Detailed Site Plan Marlboro Crossroads, Starbucks

DSP-20045

SUBJECT: Detailed Site Plan DSP-20045
Type 2 Tree Conservation Plan TCP2-110-90-02
Marlboro Crossroads Starbucks

Figure 1: Site Plan

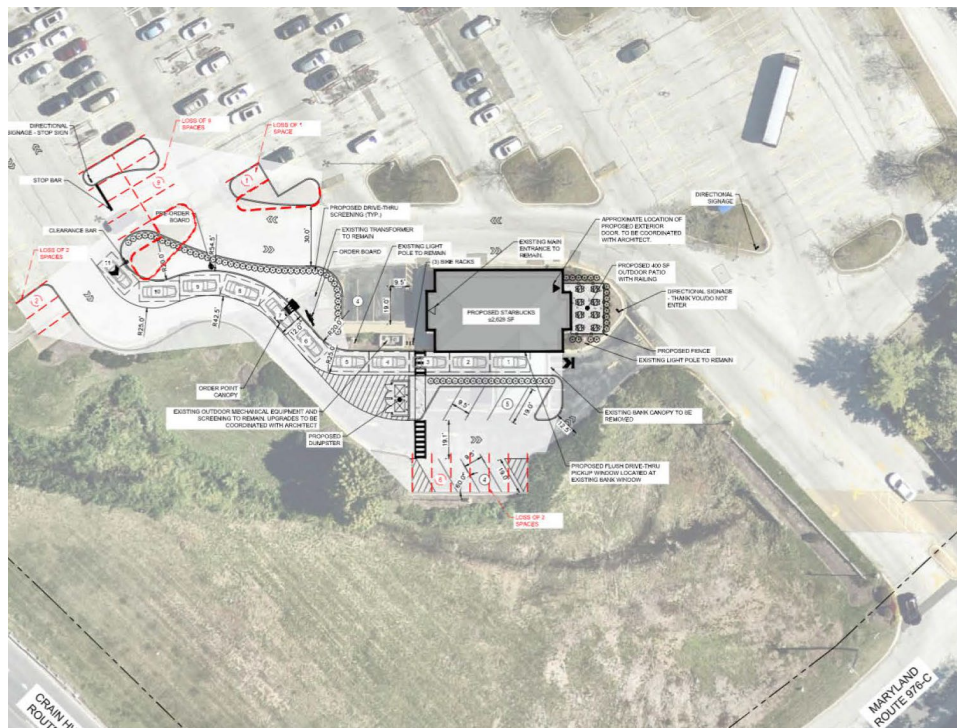
- c. Provide additional dimensions of the existing drive aisles and parking spaces on the site plan.
 - d. Label and dimension the handicap accessible parking spaces that are proposed to serve the use.

- g. Revise the parking schedule to provide the number and type of each parking space on the property, and clearly label their locations on the site plan.

Figure 4: Proposed Building-Mounted and Directional Signage

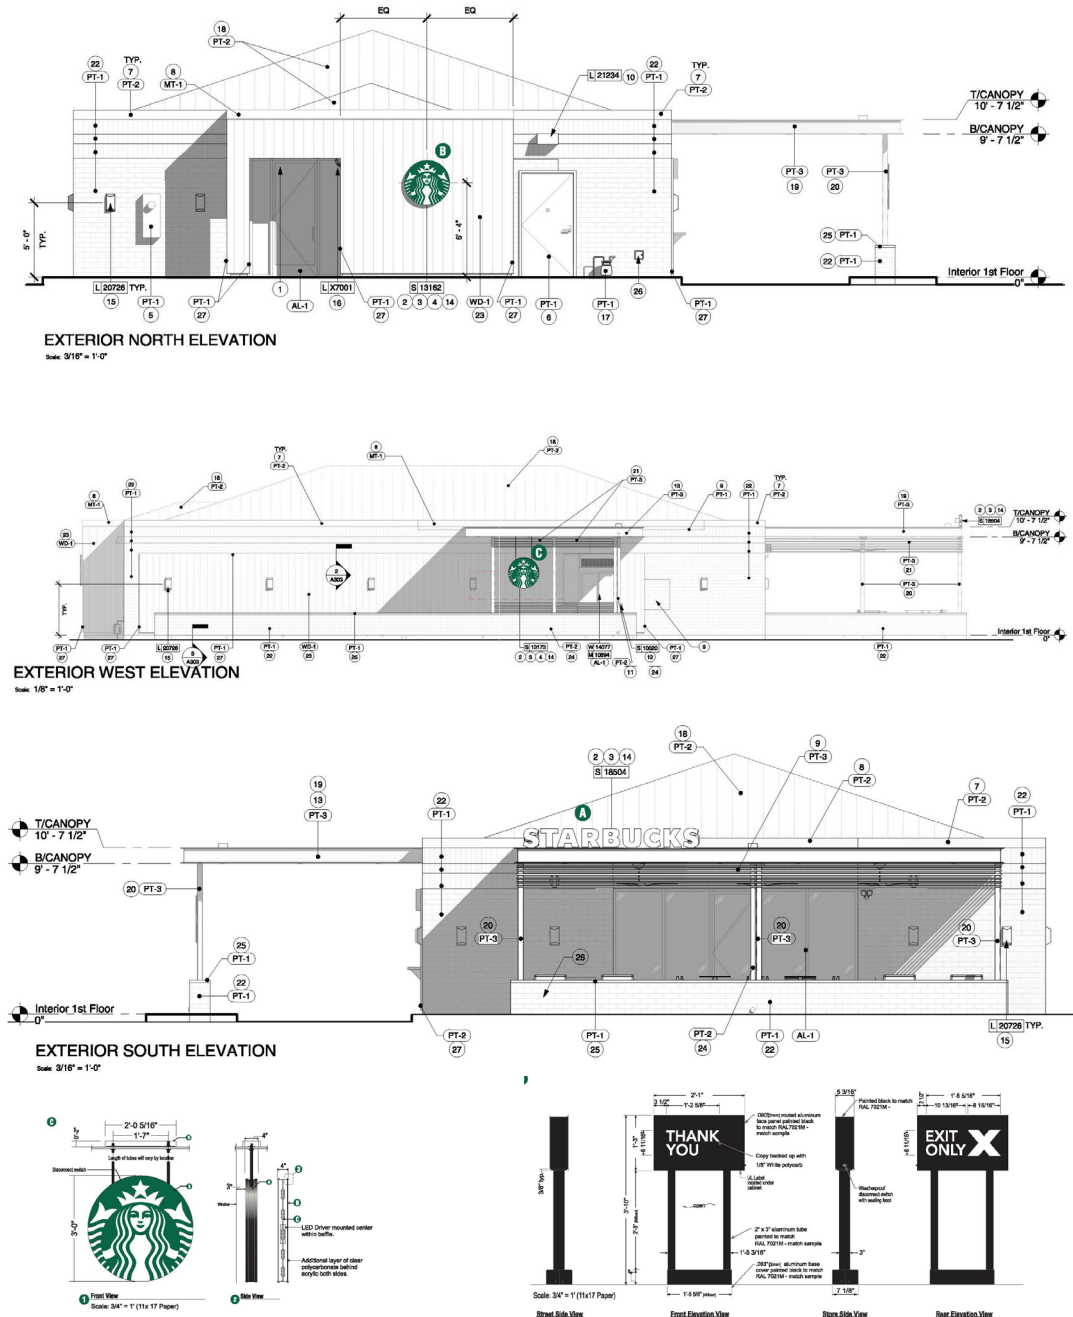
- e. Provide a signage area table demonstrating how the building-mounted and freestanding signs conform to Section 27-613 and Section 27-629 (a)(1) of the Prince George’s County Zoning Ordinance.

- f. Provide the height of the sign proposed above the roof line to demonstrate that it is in conformance with Section 27-613(b)(1) of the Prince George’s County Zoning Ordinance.

TYPE II TREE CONSERVATION PLAN

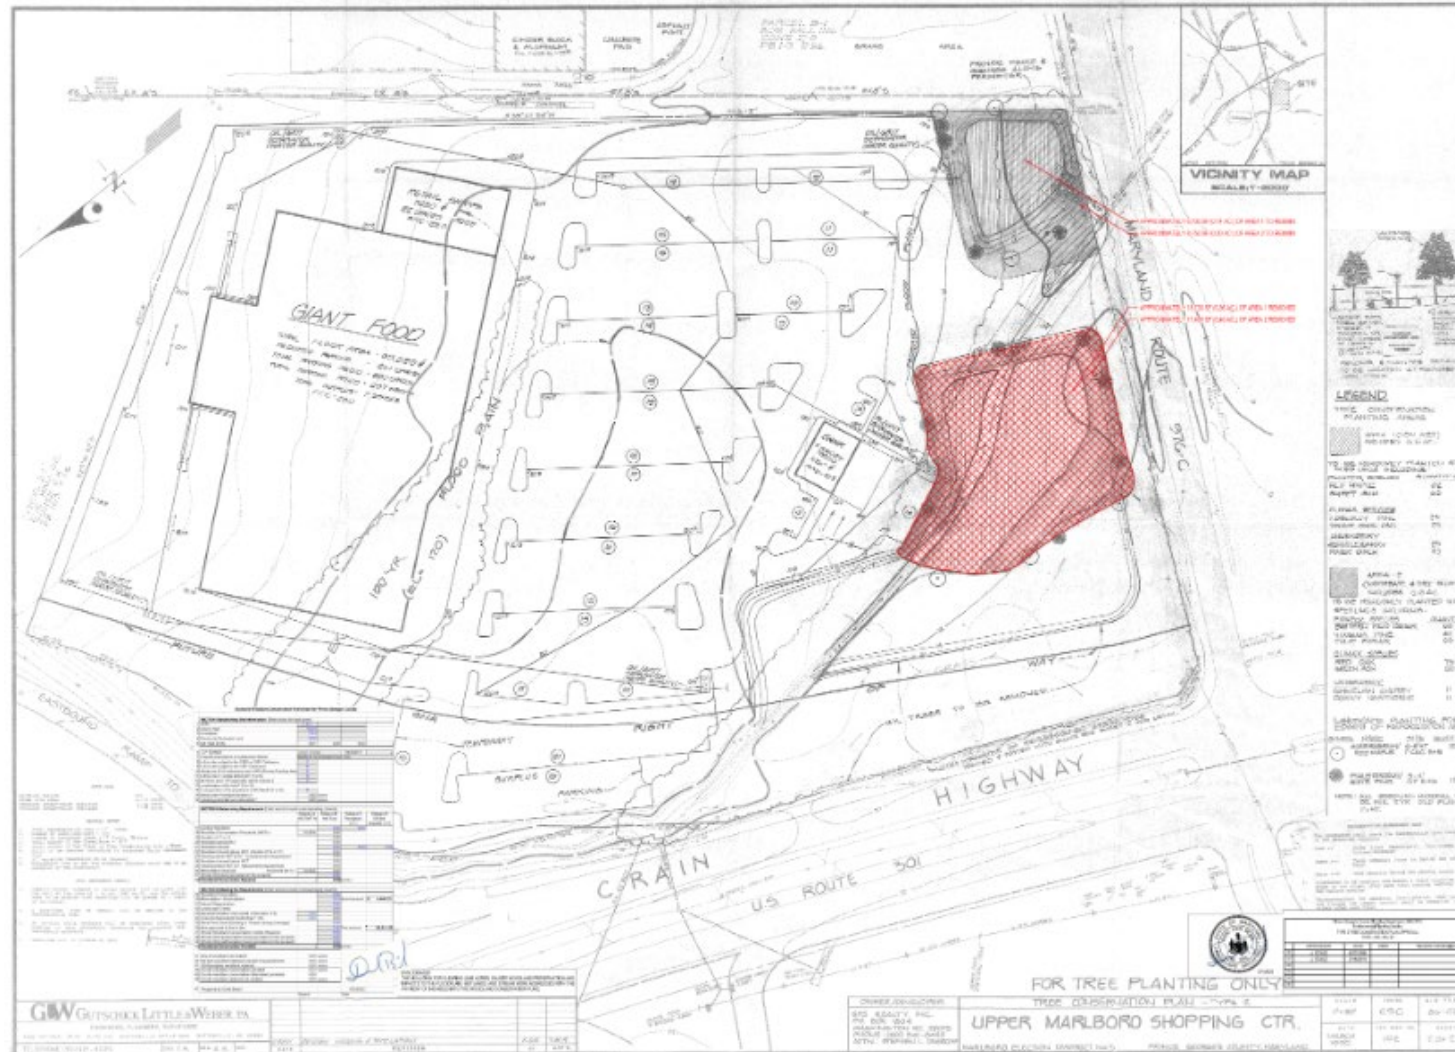
- (2) Correct the woodland conservation worksheet to reflect a gross tract area of 10.76 acres and adjust the rest of the worksheet accordingly.
- (3) Correct the case number in the Environmental Planning Section approval block from "TCP2-100-90-02" to "TCP2-110-90".
- (4) Have the worksheet and plans signed and dated by the qualified professional who prepared them.
